PROJECT: LOMBARDY PUBLIC SCHOOL PARKING, SEPTIC
AND SITE WORKS - PHASE 2 MECHANICAL AND
ELECTRICAL UPGRADES

ADDENDUM No.: 02

PROJECT No.: 209-00237-00

DATE: 2026-04-28

AR-D-501 SCALE: 1:10

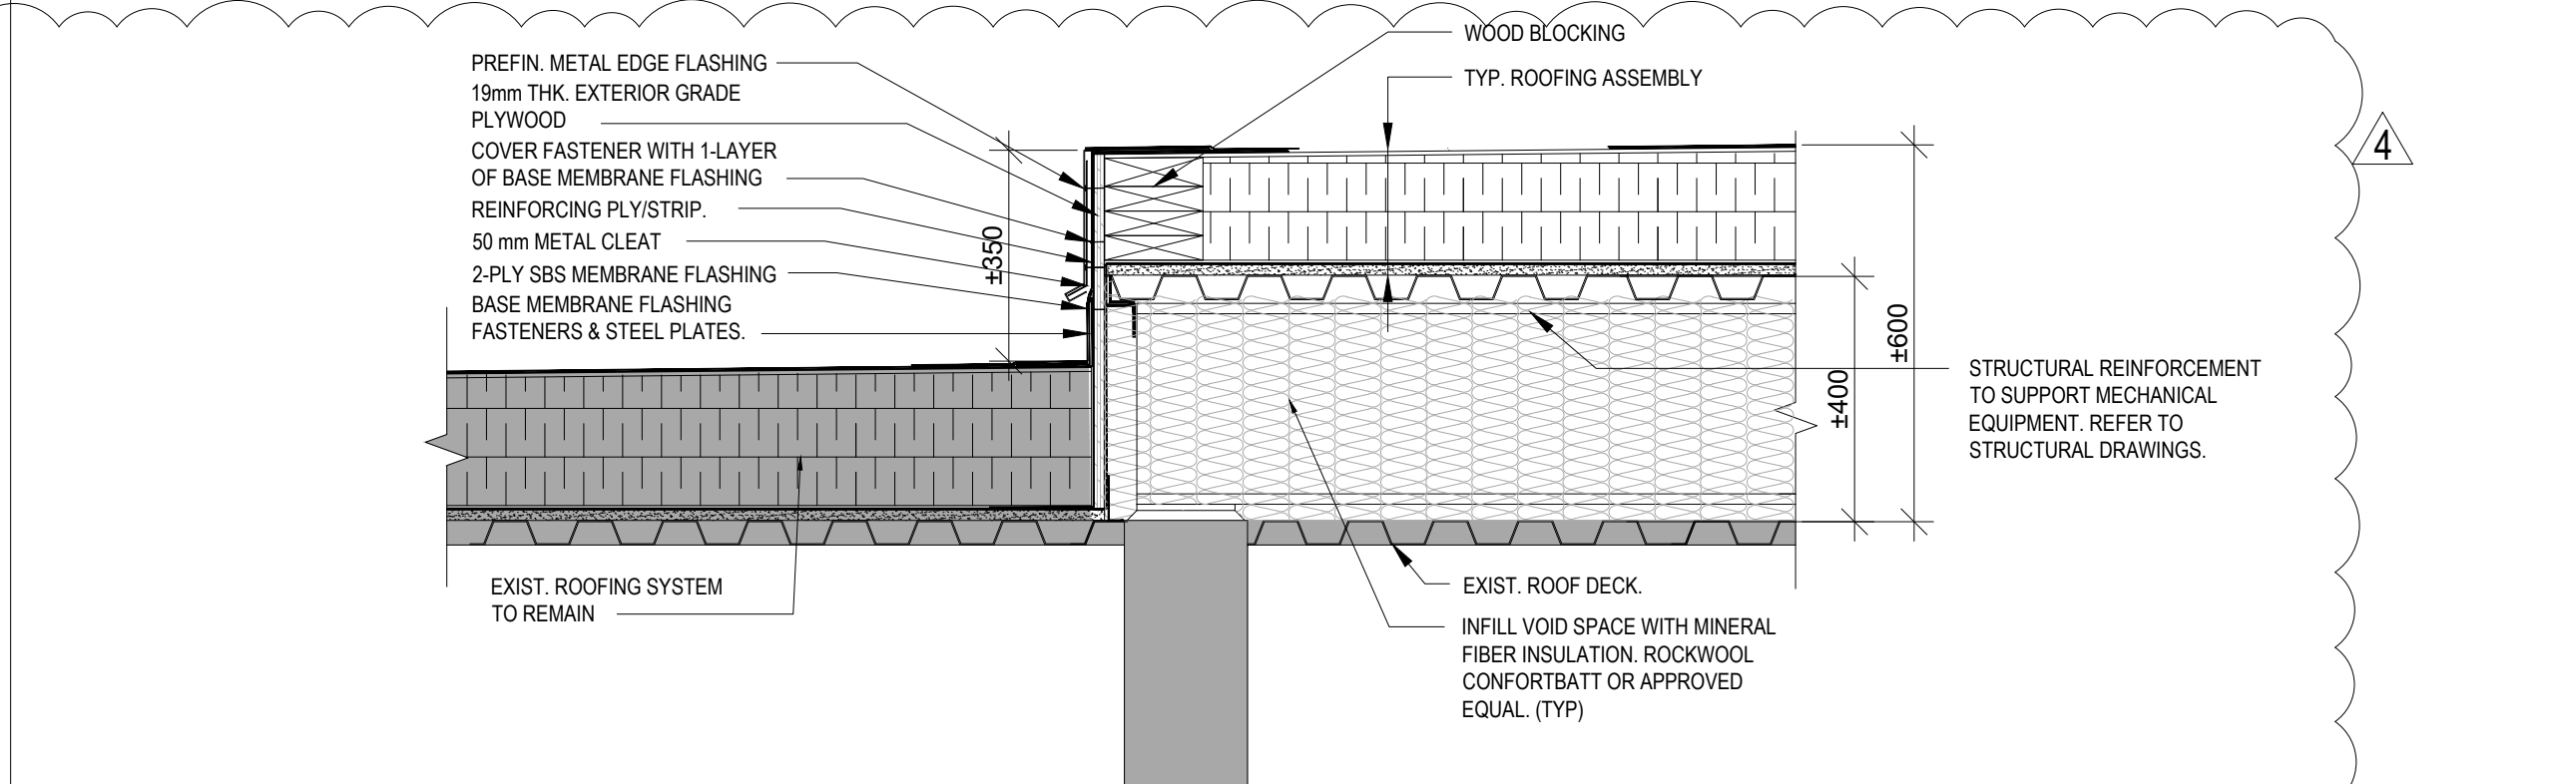
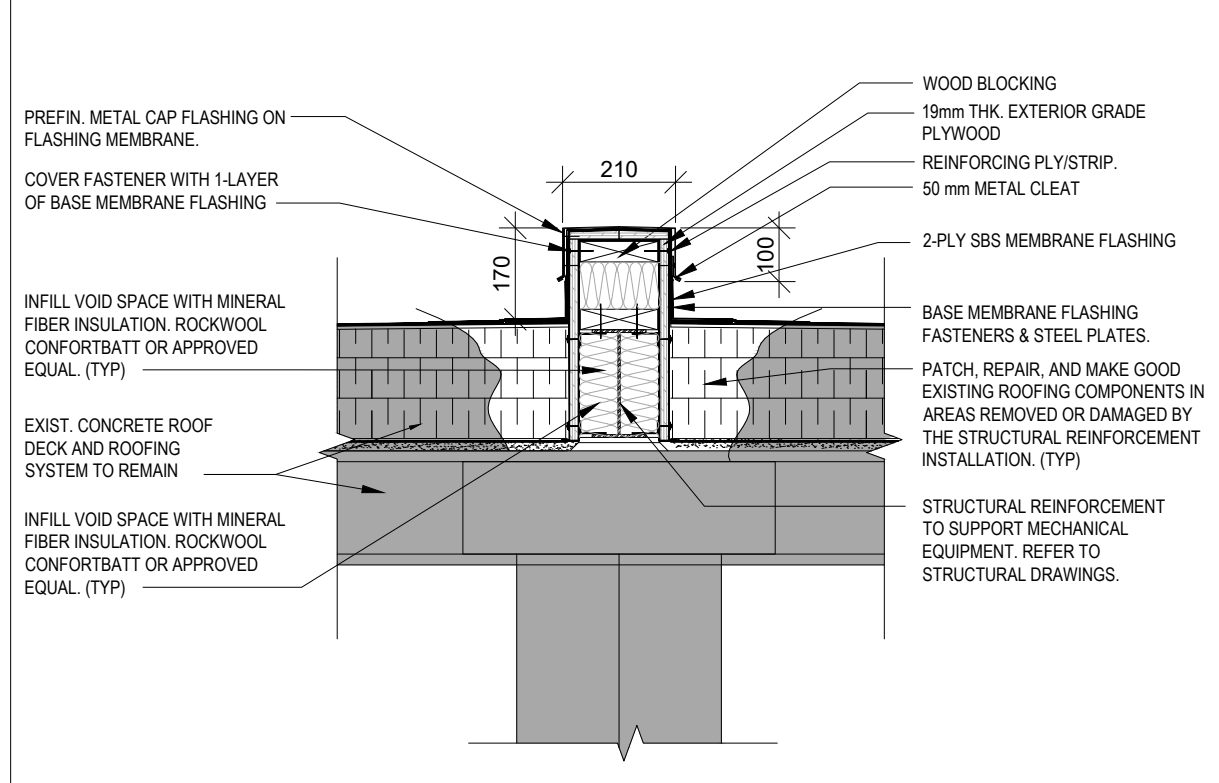
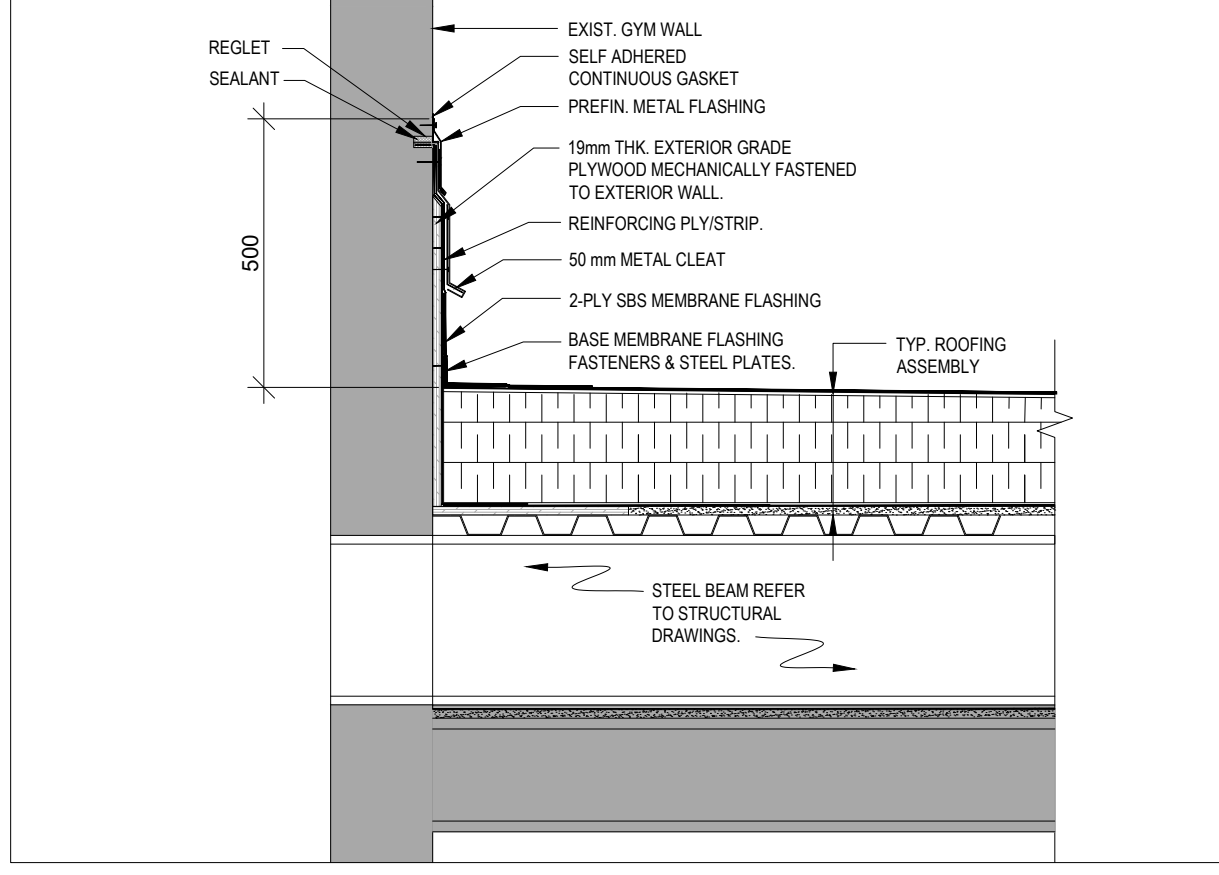
AR-D-501 ROOF PLAN AND DETAILS

1. Detail name and number added.
2. Detail dimensions added
3. Details 5 & 6 added
4. Modifications and added notes on the roof plan
5. Note added for provision of "crickets"
